Subject: Peach Bottom Atomic Power Station, Units 2 and 3
Change to the Technical Specifications Bases
Regarding the Power/Flow Map

The purpose of this letter is to inform you of a change to the Peach Bottom Atomic Power Station (PBAPS), Units 2 and 3 Technical Specifications (TS) Bases, Figure 1.1-1, "APRM Flow Bias Scram Relationship to Normal Operating Conditions." This change is being implemented in accordance with 10 CFR 50.59.

Figure 1.1-1

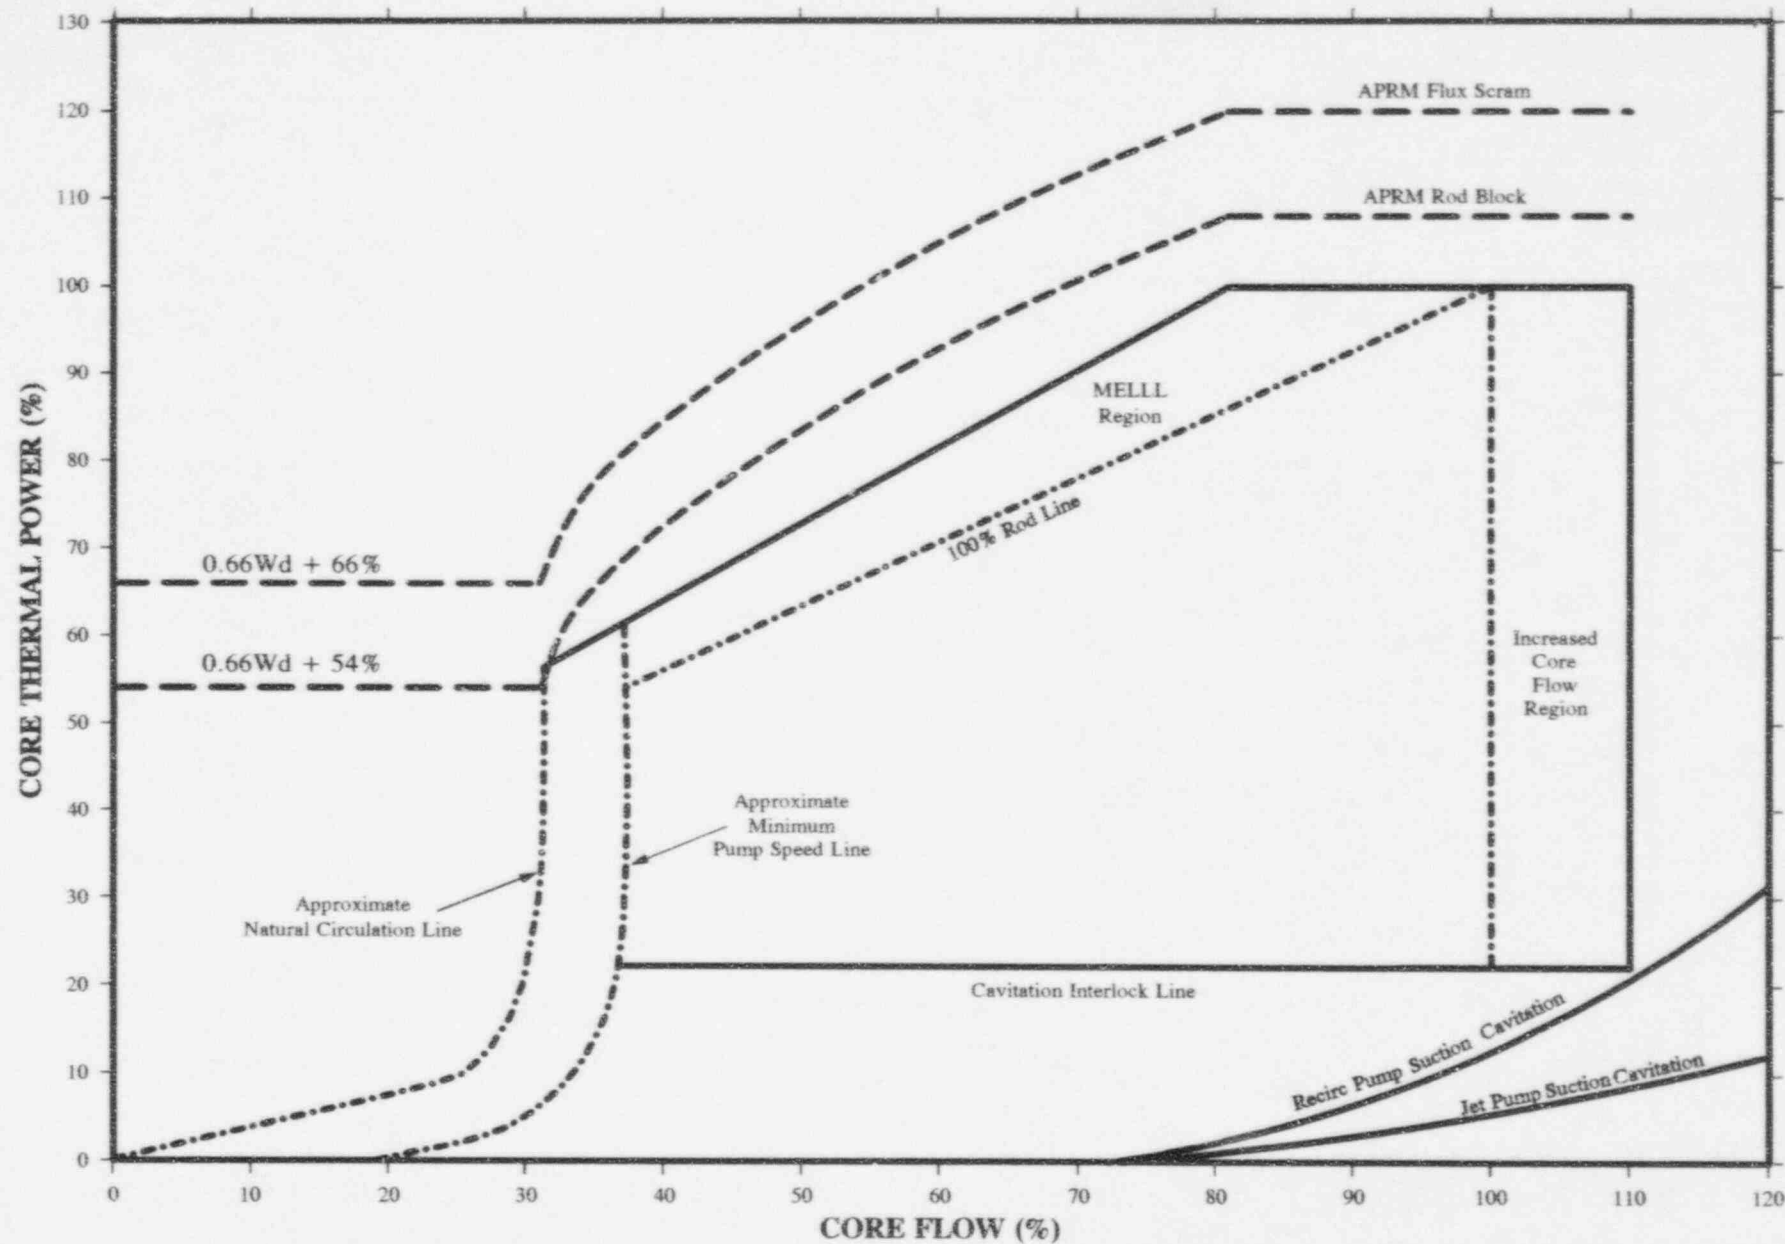
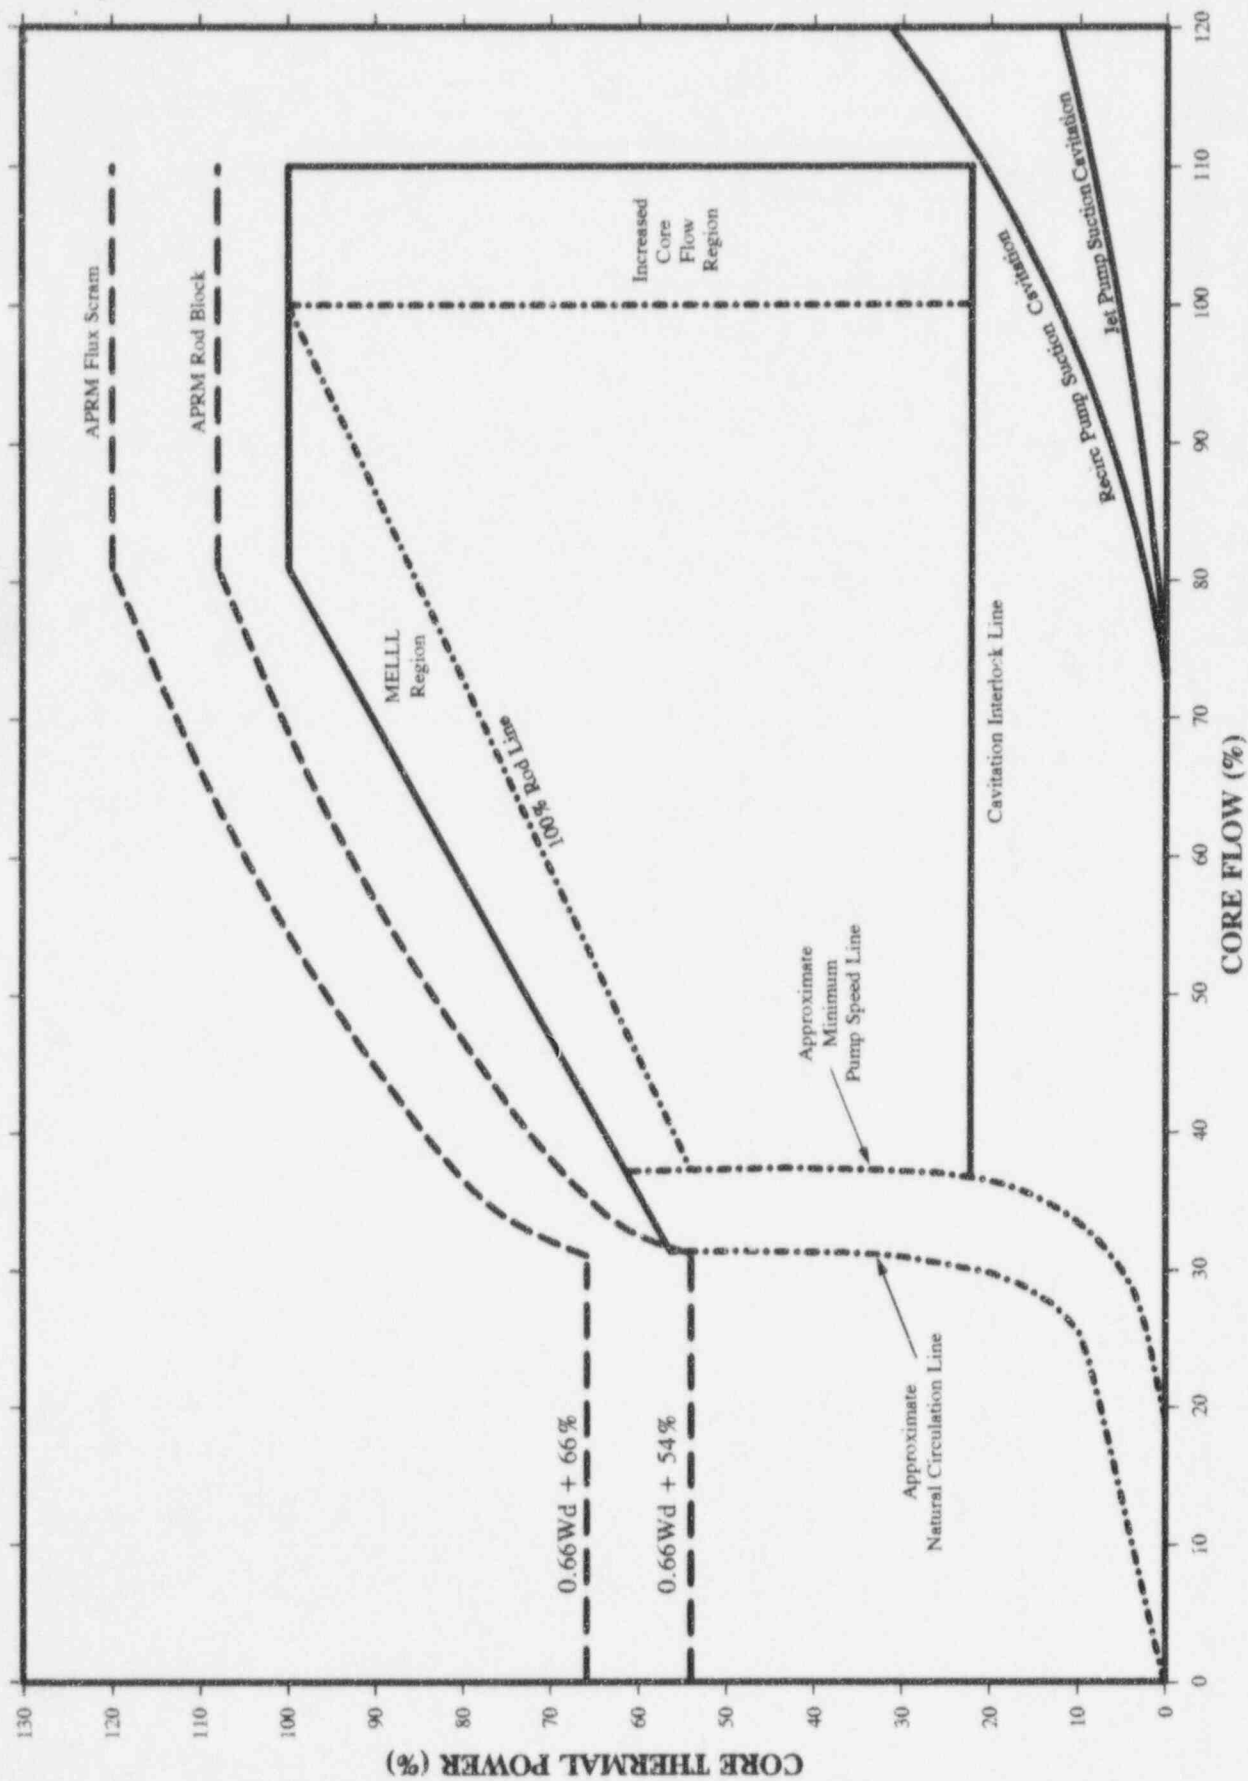
The purpose of this change is to allow a maximum core flow of 110% of rated flow from 100% rated thermal power to the cavitation interlock line as shown in the revised Bases Figure 1.1-1 for both units (Attachment 1). This change will allow PBAPS, Units 2 and 3 to maximize generation throughout the entire fuel cycle. This change has been incorporated utilizing appropriate GE Nuclear Energy analyses. The PBAPS, Unit 2 Figure 1.1-1 is currently being implemented. The PBAPS, Unit 3 Figure 1.1-1 will be implemented in association with Amendment No. 211 concerning power rerate.
